ECN/PCN No.: 3455

For Manufacturer		
Product Description: Low Frequency SMD Crystal		Abracon Part Number / Part Series: ABS25
Affected Revision: U	New Revision: V	Application
		<input checked="" type="checkbox"/> Series
		<input type="checkbox"/> Part Number
		<input type="checkbox"/> Safety
		<input checked="" type="checkbox"/> Non-Safety

Engineering/Process Change Notice

Prior to Change:

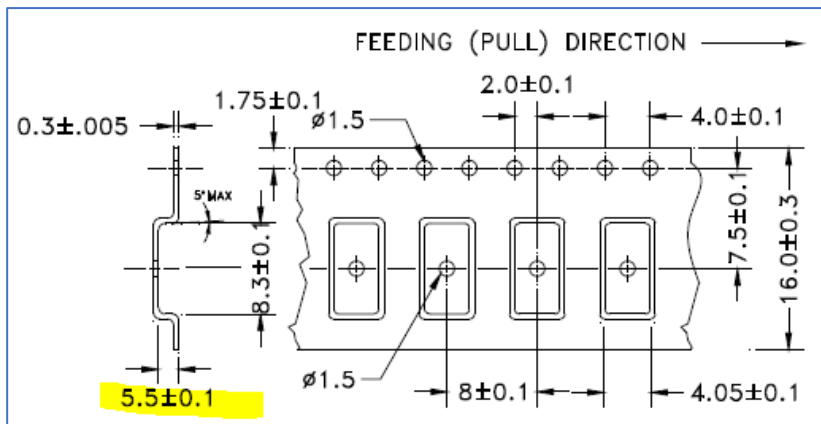
1. ROHS Statement
 - a. Pb in High Temperature Solder (exempt per RoHS 2002/95/EC Annex (7))
2. Electrical performance
 - a. Frequency Coefficient (β):
 - i. Min = -0.040 ppm/T²
 - ii. Typ = -0.034 ppm/T²
 - iii. Max = -0.028 ppm/T²
3. Mechanical Dimensions (millimeters)
 - a. Top view; width dimension = 3.8 mm MAX
 - b. Top view; length dimension = 8.0 MAX
 - c. Side view; height dimension = 2.5 MAX

4. Tape Packaging Dimension (millimeters)
 - a. Depth of part-insert dimension = 5.5 ± 0.1

After Change:

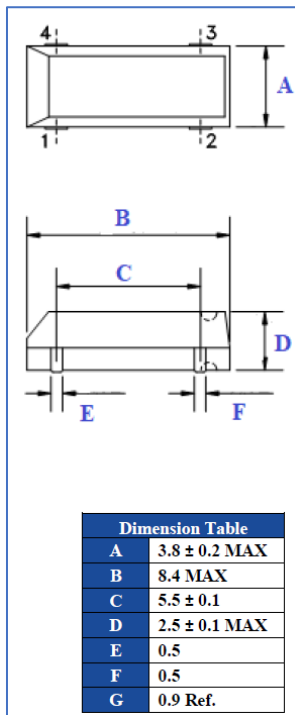
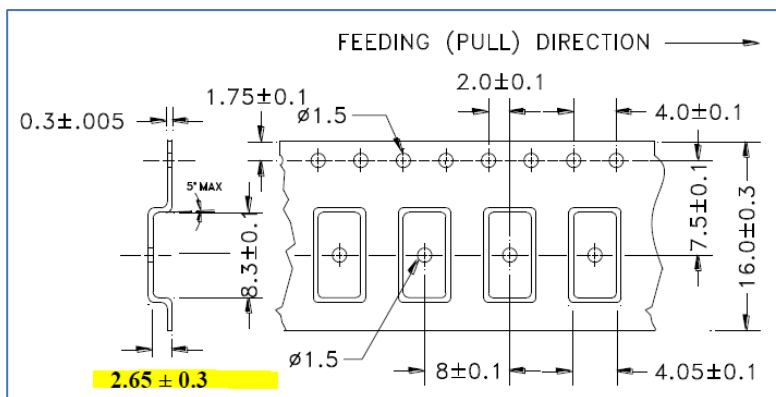
1. ROHS Statement
 - a. Pb in high temperature solder (exempt 7(a) per 2015/863/EU Annex)
2. Electrical performance
 - a. Frequency Coefficient (β):
 - i. Typ = -0.035 ± 0.01 ppm/ $^{\circ}\text{C}^2$
3. Mechanical Dimensions (millimeters)
 - a. Top view; width dimension = 3.8 ± 0.2 MAX (increase)
 - b. Top view; length dimension = 8.4 MAX (increase)
 - c. Side view; height dimension = 2.5 ± 0.1 MAX (increase)

4. Reel Packaging Dimension (millimeters)
 - a. Depth of part-insert dimension = 2.65 ± 0.3 (original dimension on the datasheet was a typing error)

OUTLINE DRAWING:

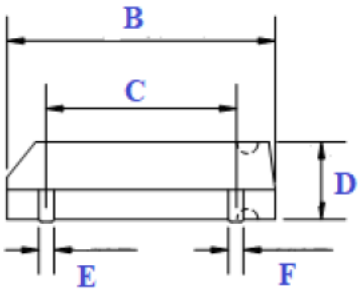
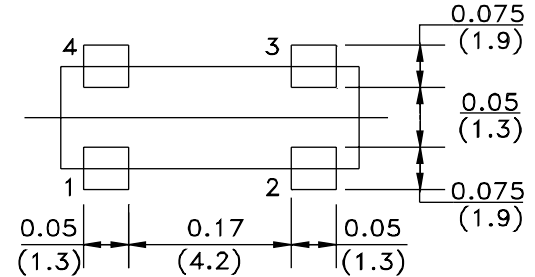
Dimension Table	
A	3.8 ± 0.2 MAX
B	8.4 MAX
C	5.5 ± 0.1
D	2.5 ± 0.1 MAX
E	0.5
F	0.5
G	0.9 Ref.
